RFI #: 4
 Date: 12/1/2011
 Job: EB-02 Keller Springs Lofts
 Phone: 877-777-5115

Subject: RFI #4

RFI #: 6
 Date: 12/1/2011
 Job: EB-02 Keller Springs Lofts
 Phone: 877-777-5115

RFI #: 180
 Date: 8/7/2012
 Job: EB-02 Keller Springs Lofts
 Phone: 877-777-5115

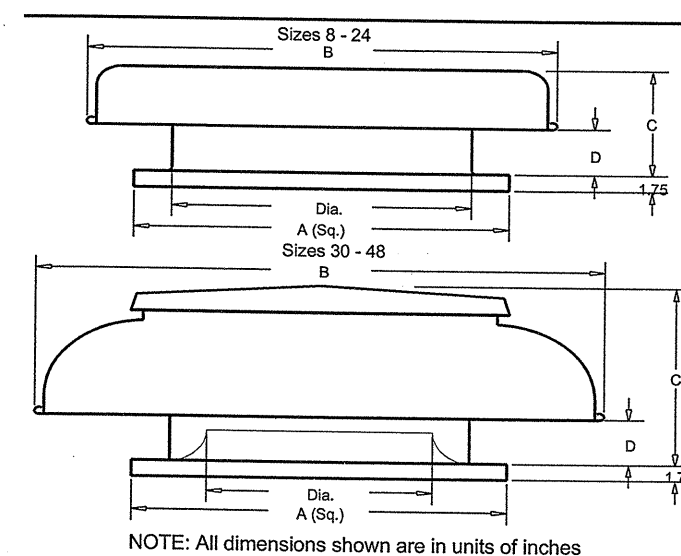
Request: Please provide detail for door and location going to roof on sheet 5.4 also provide sheet detail of stair #4 Also please provide same information for stair #5 Date Required: 12/8/2011

PLEASE SEE THE ATTACHED SHEETS WITH STAIR SECTION #4 AND #5

THE ROOF TOP DOOR DETAILS HAS ALWAYS BEEN LOCATED ON 8-8.2 AND KEYED ON THE ROOF PLAN 3.5D. AS SHEET 5.5B IS NEW TO THE SET I HAVE ADDED IT TO THE INDEX AS WELL
